# **CONNECTION ASSESSMENT & APPROVAL PROCESS**

*Project: Replacement of 230kV Breakers  
PL24 & KT22 at R.H. Martindale TS*

***CAA ID No. 2002-EX025***

*Date: 16<sup>th</sup> April 2002*

Breakers that are to be replaced

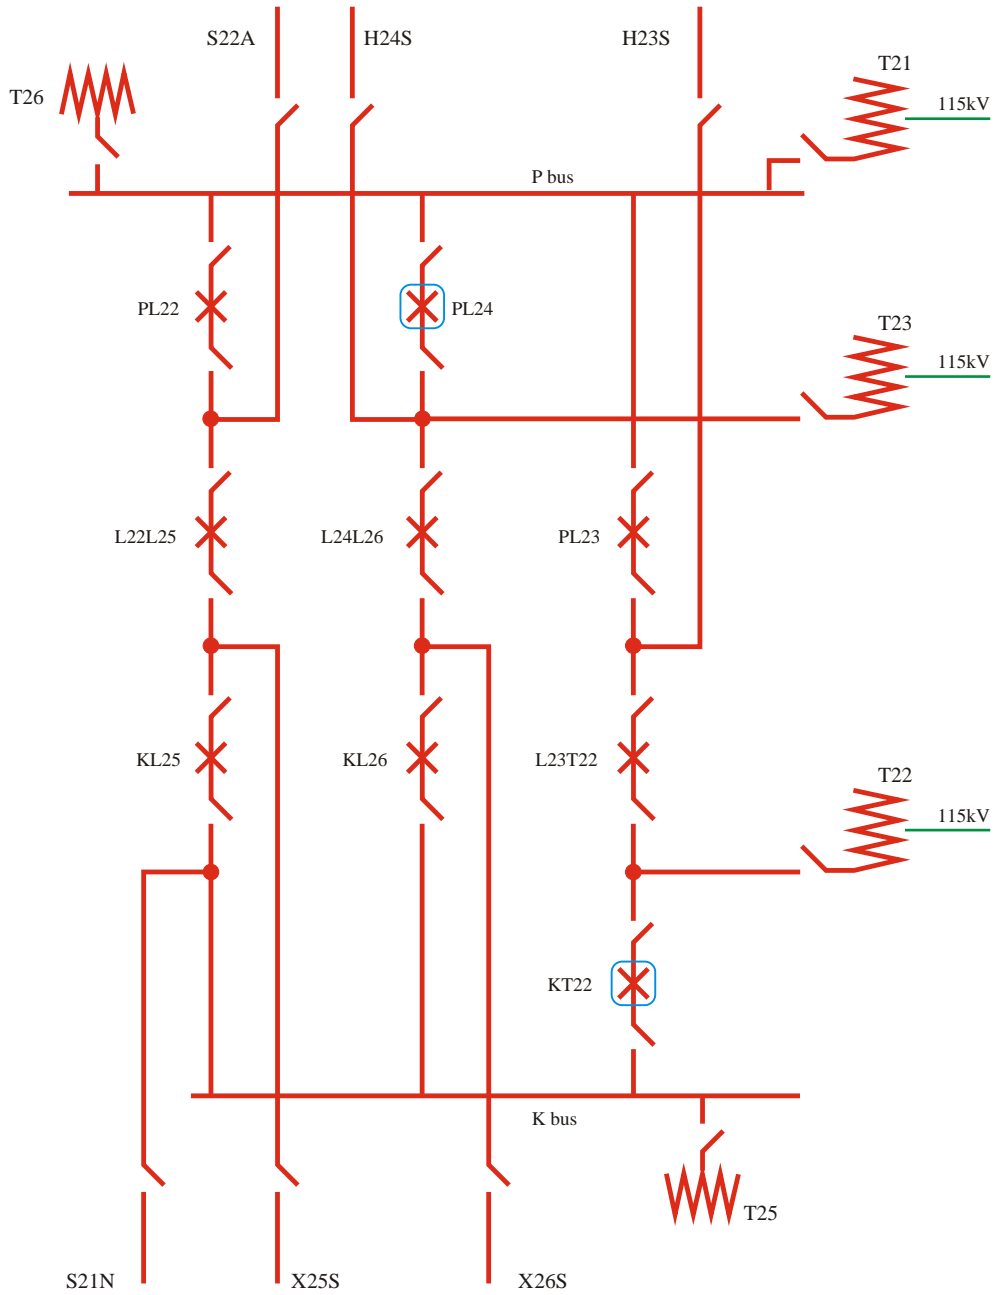
The physical location of the two breakers that are to be replaced at Martindale TS is shown in Diagram 1.

Following the replacement of breakers PL24 & KT22, three of the breakers at Martindale TS will be rated at 50kA, while all of the remaining breakers will be rated at 40kA. While the two replacement breakers will not comply with the Transmission System Code that requires a rating of 63kA for 230kV breakers, the new breakers will represent a marked improvement over the rating of 23kA for the existing breakers.

Once the two air-blast breakers at Martindale TS have been replaced, the minimum fault rating of the existing facilities at Martindale TS will then be 40kA, providing an additional margin of 17kA to accommodate any future increases in fault level. This is expected to be adequate for possible future developments, however should the fault level increase to above the 50kA rating of the new breakers due to developments by a third party, then the subsequent replacement of these two breakers would be expected to be undertaken at Hydro One's expense.

Since the replacement of breakers PL24 & KT22 at R.H. Martindale TS is considered to represent a like-for-like replacement of existing facilities, it will have no adverse impact on the IMO-controlled grid.

It is therefore recommended that a Notification of Approval of the Connection Proposal be issued.
